**REQUEST**

Current Zoning: R-5 (single family residential)  
Proposed Zoning: NS (neighborhood services)

Approximately 8.12 acres located on the north side of Randolph Road, north of Eastover Ridge Drive, east of Cranbrook Lane.

The petition proposes to allow a development consisting of residential units and a medical office on a parcel of land currently developed with a radio transmission tower.

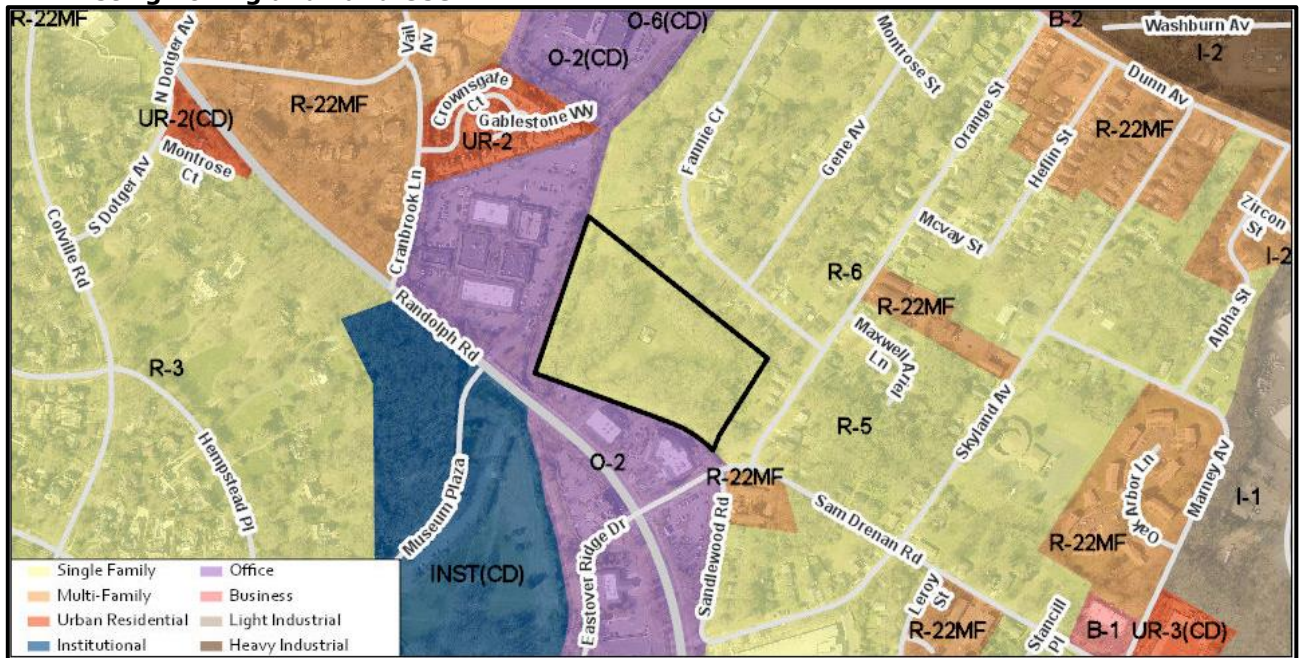
1. The site plan must say dedication is to Mecklenburg County not Mecklenburg County Park and Recreation.

1. Provide a sidewalk connection from the proposed medical office building to a public street.
2. The NS district requires a 6-foot sidewalk along all streets. Revise to plan to reflect 6' requirement.
3. Clarify if landscaping will be provided between Development Areas A and B, screening parking and maneuvering areas. Site plan shows property line between 2 development areas.

4. A right-of-way abandonment is no longer required at this revised intersection. The existing right-of-way may remain, unless an abandonment or land swap is pursued by the petitioner.
